Addendum No.: 1

Bid#: 24-10-2

Project Name: Highway LA-21 Lift Station

SHEET NO.
2
SHEET 2 of 22

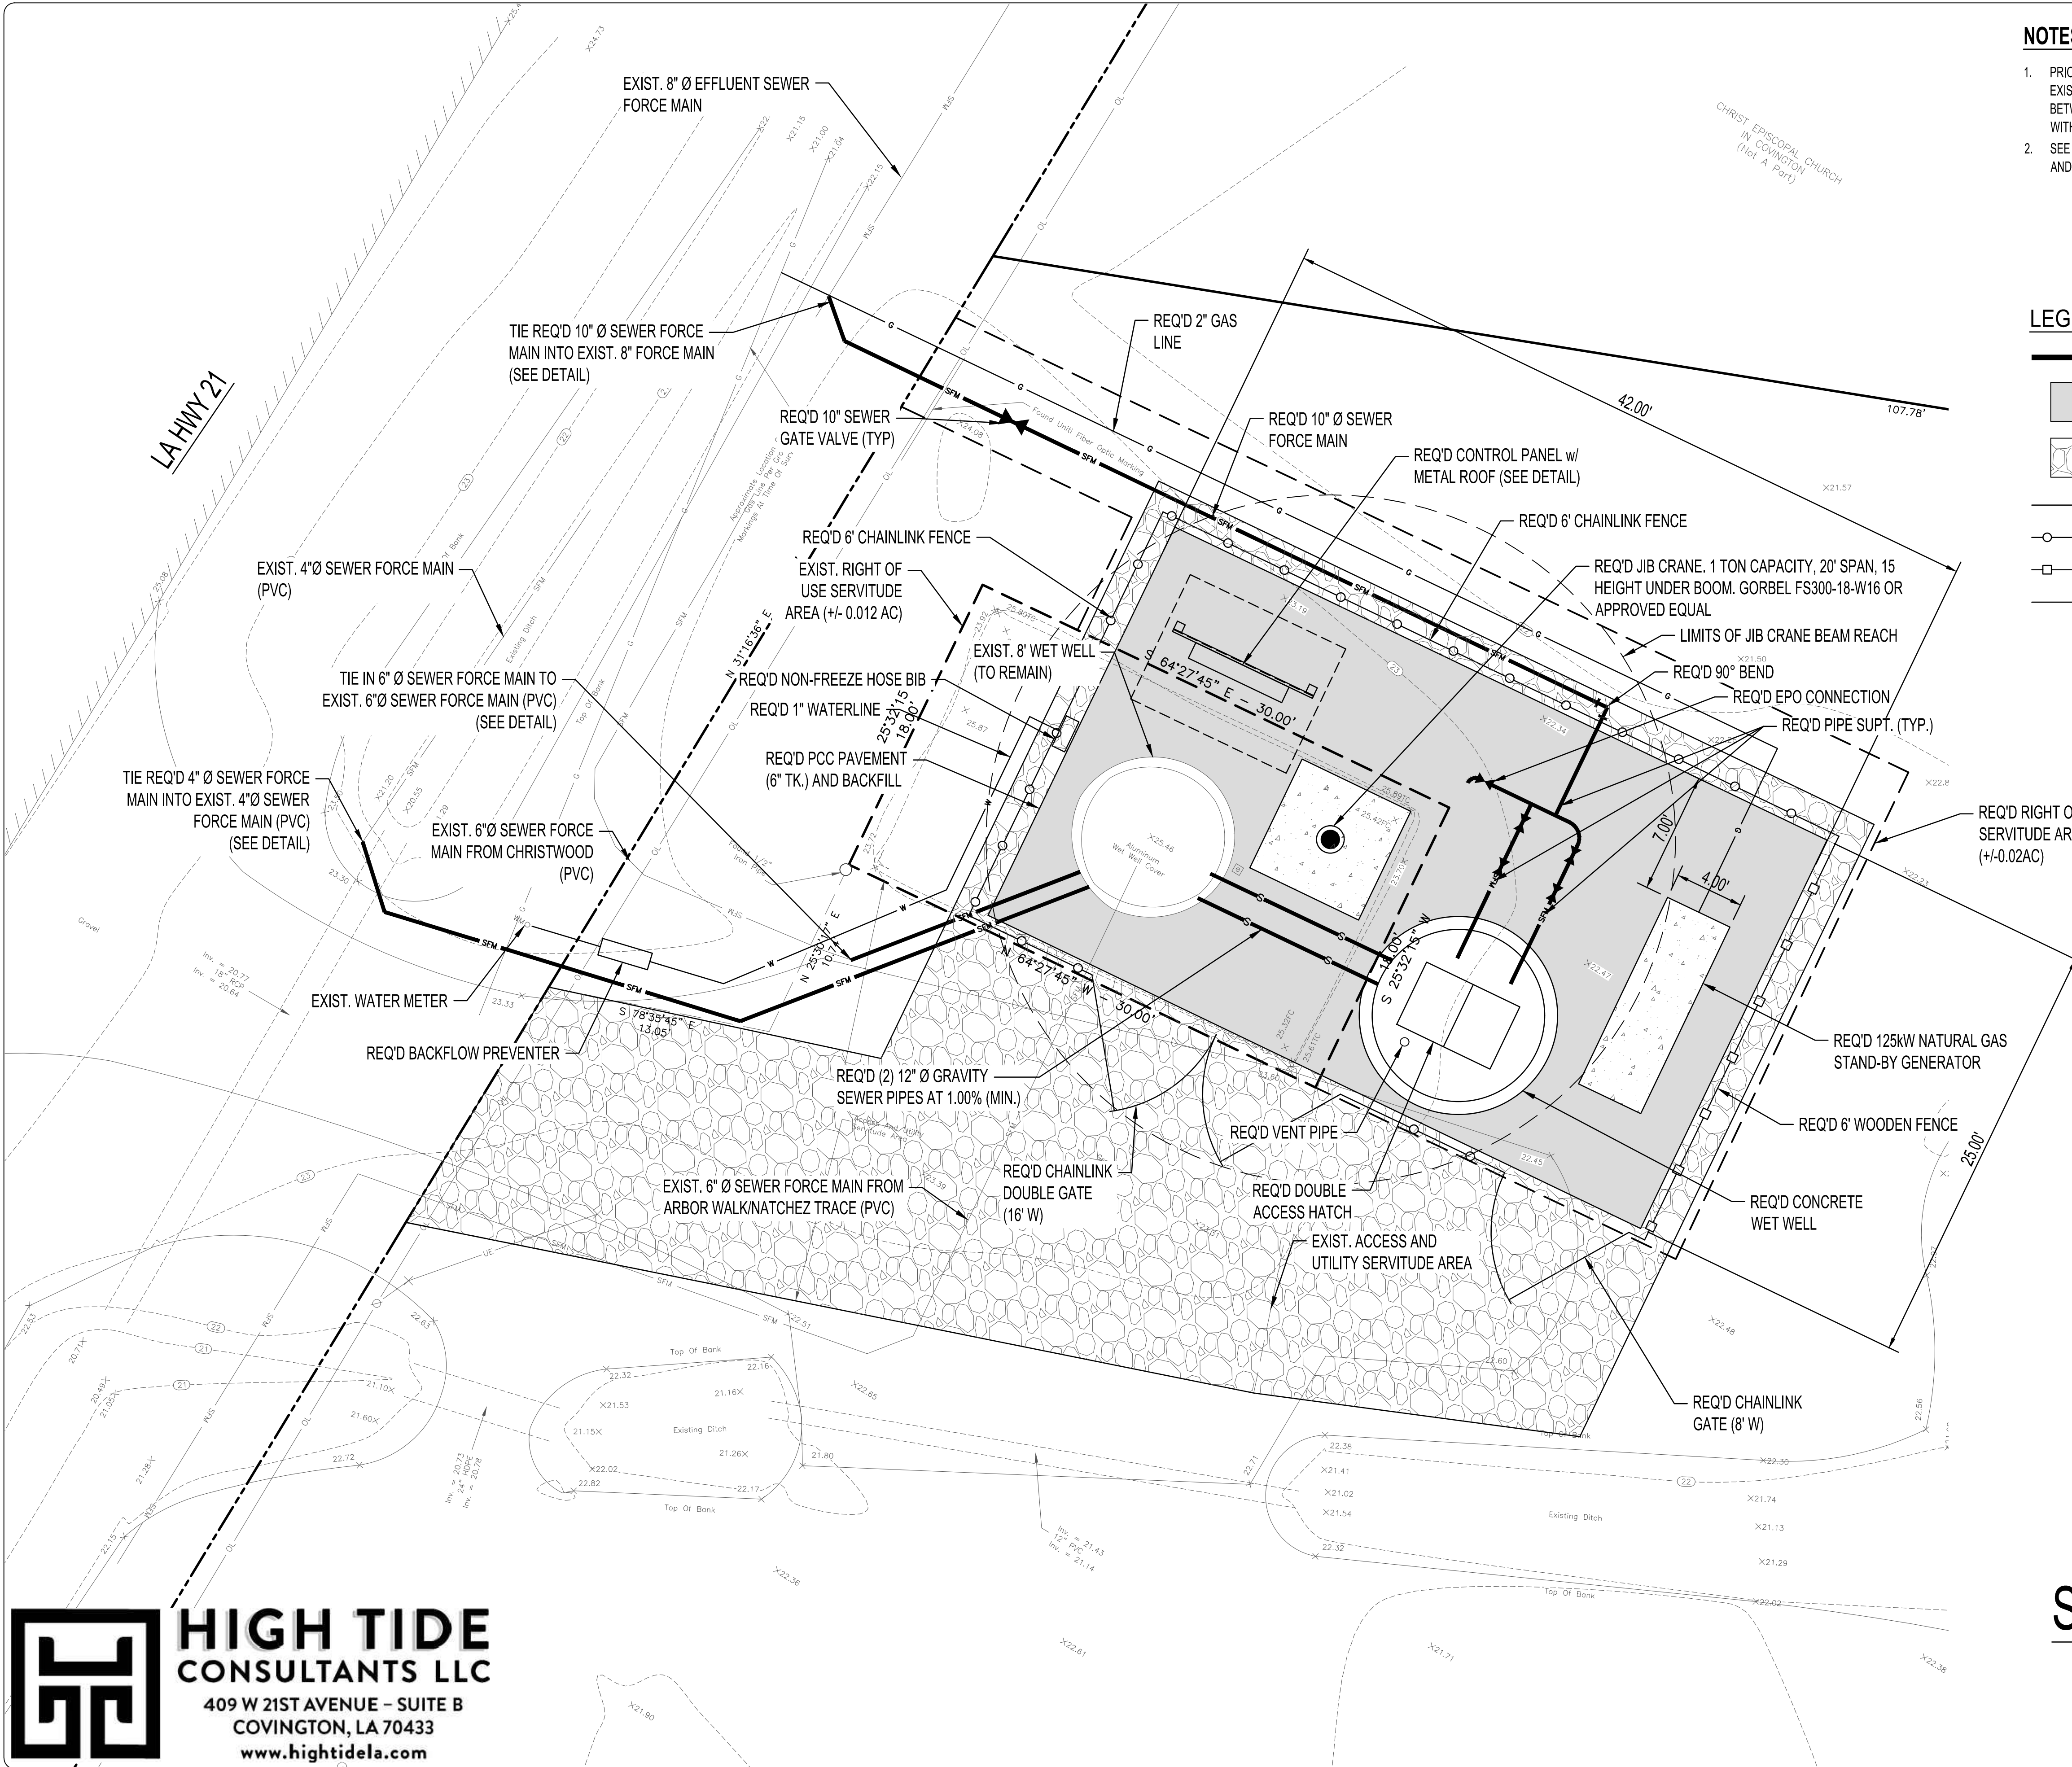
1. Sheet 2 – General Notes:

- Revise Item No. 129:

Change from ‘6” THICK AGGREGATE SURFACE COURSE’ to ‘AGGREGATE SURFACE COURSE’

SITE LAYOUT PLAN

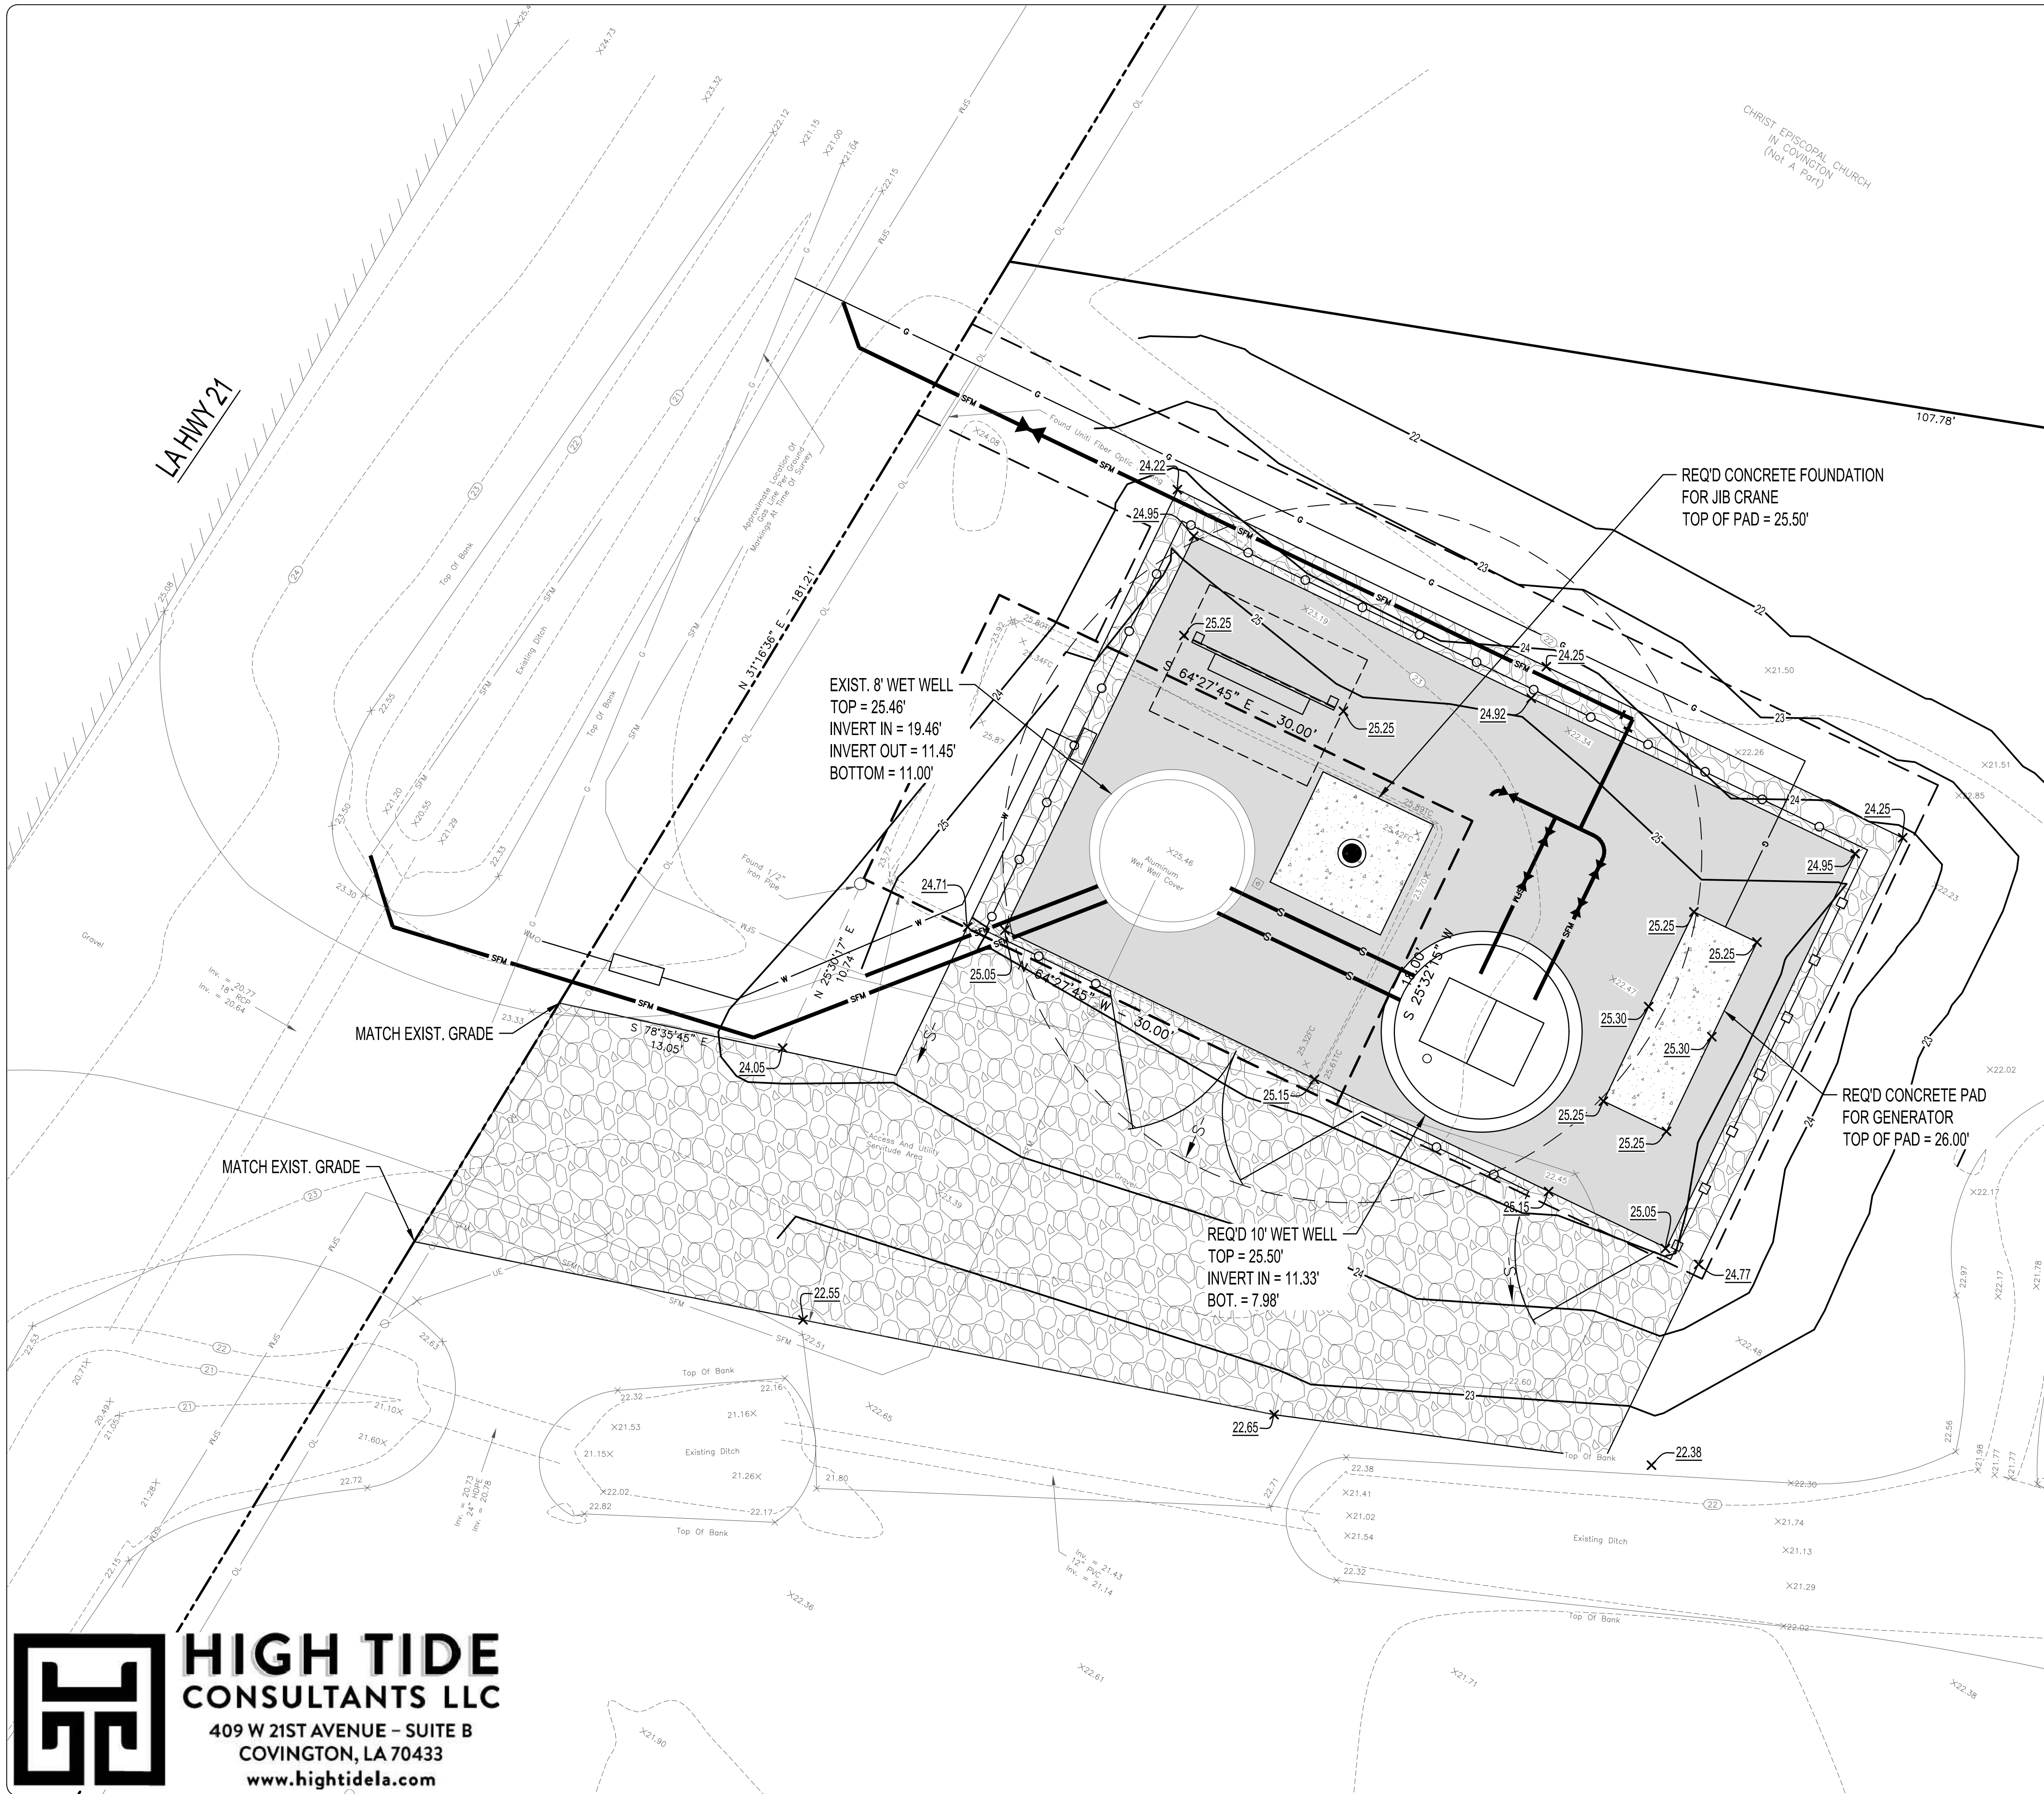
2. Sheet 10 – Site Layout Plan

- Revise Legend - Required:

Change from ‘6” AGGREGATE SURFACE COURSE’ to ‘AGGREGATE SURFACE COURSE’
